MAINE TURNPIKE AUTHORITY

ADDENDUM NO. 2

CONTRACT 2019.11

**NORTHERN BRIDGE REPAIRS, 6 LOCATIONS AND
EMERGENCY VEHICLE RAMPS AND
NEW GLOUCESTER TOLL PLAZA REHABILITATION
MILE 62.3 TO 95.6**

SHEET NUMBER: EVR-08

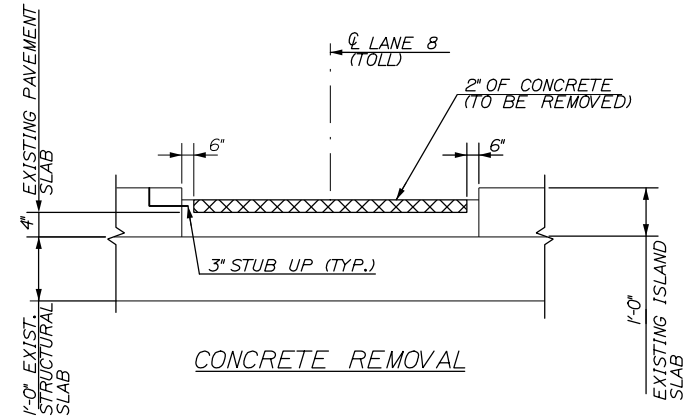
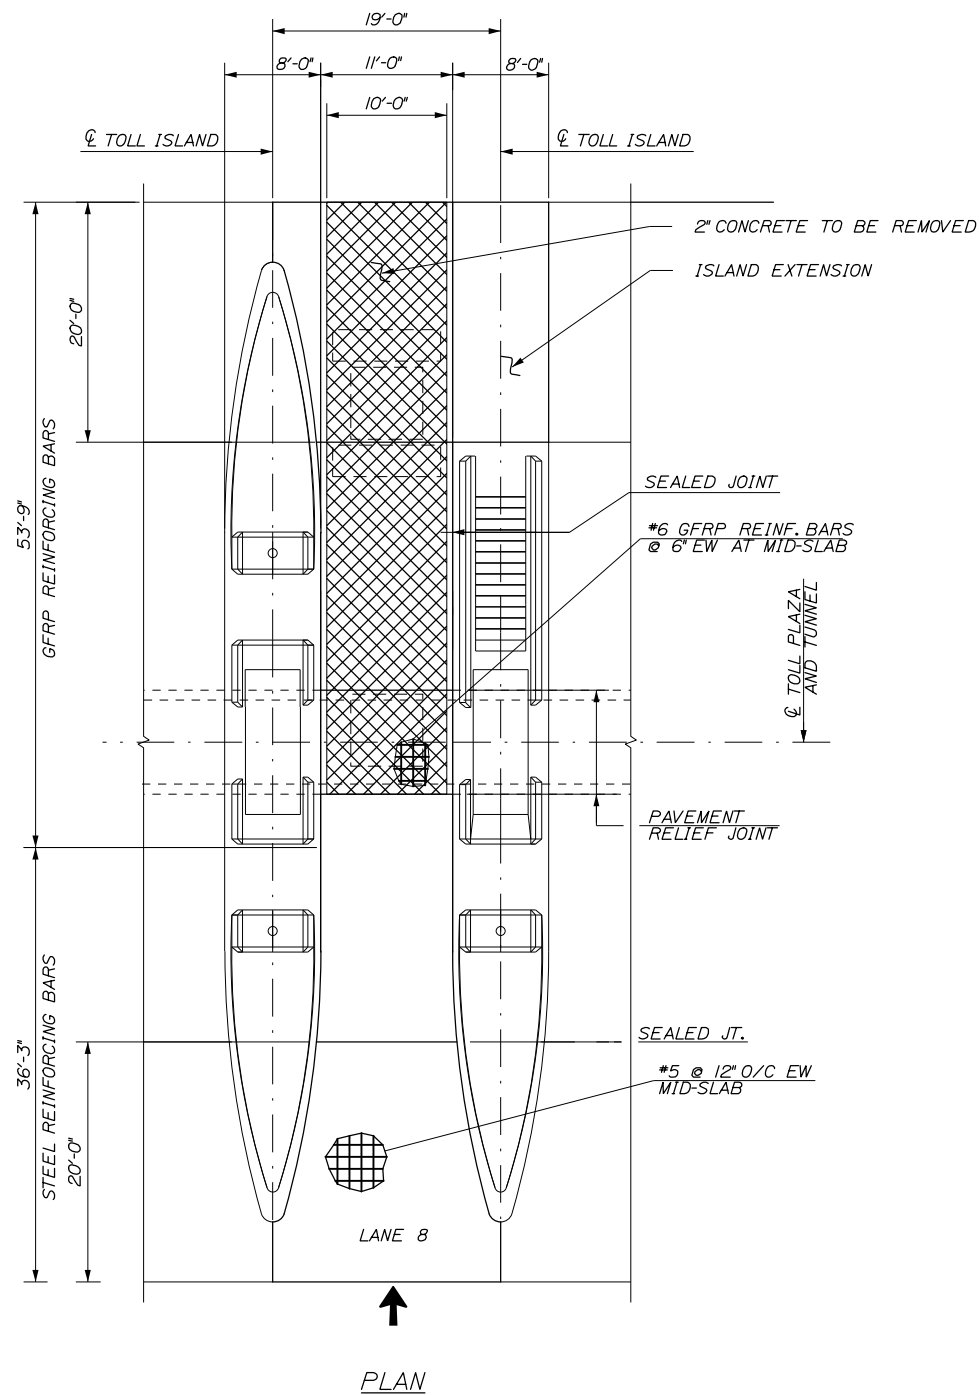
Plan sheet 16 of 105, “Bennett Road EVR (Mile 68.6) Limit of Disturbance Plan” is deleted and replaced in its entirety with the attached revised sheet 16.

No.	Revision	By	Date
1	Revise Areas	DSM	3/19

DEMO PAVEMENT PLAN

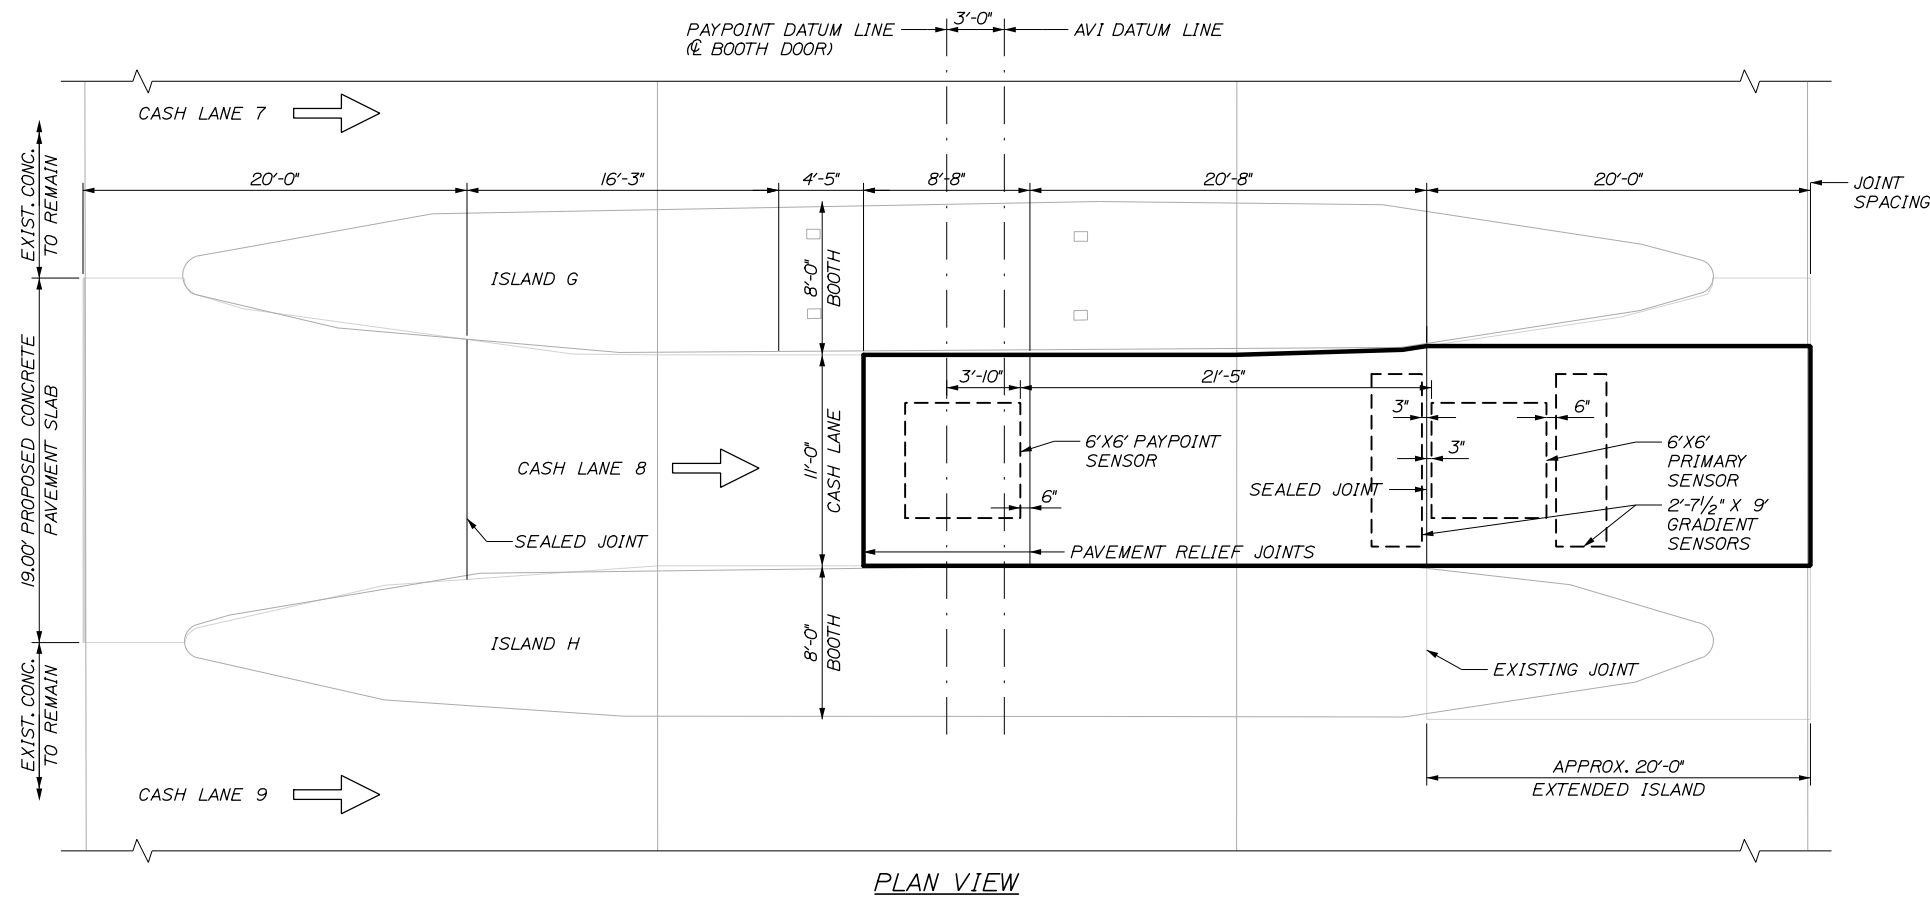
Plan Sheet 103 of 105, “Demo Pavement Plan” is deleted and replaced in its entirety with the attached revised sheet 103.

SHEET NUMBER: S-02

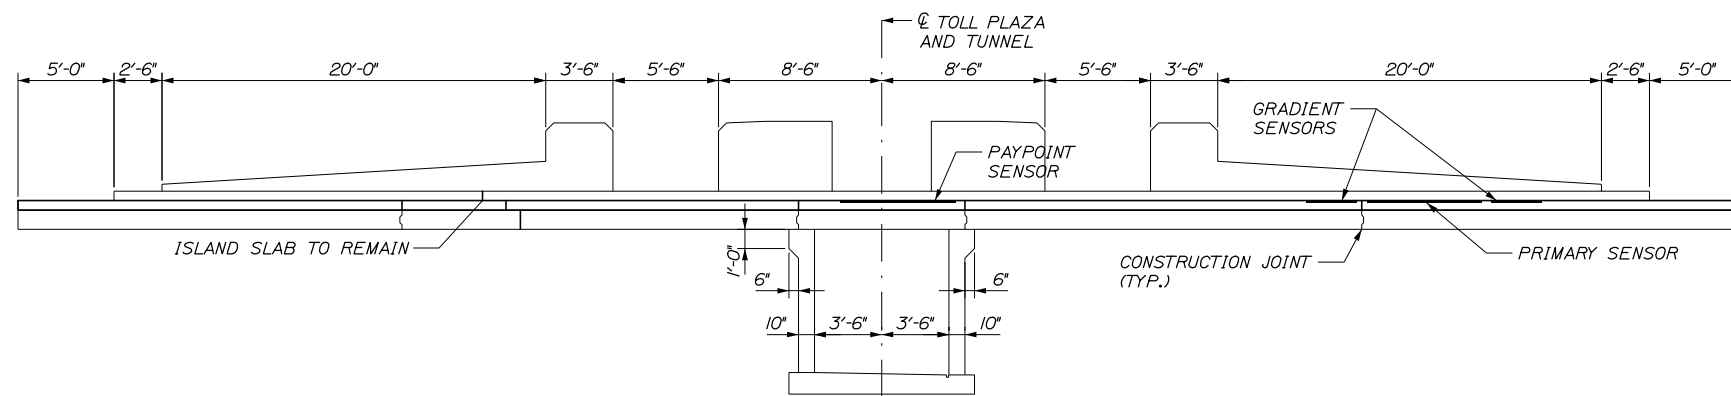
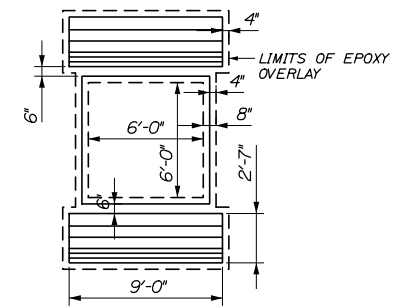
Plan Sheet 104 of 105, “Rehab Pavement Slab” is deleted and replaced in its entirety with the attached revised sheet 104.
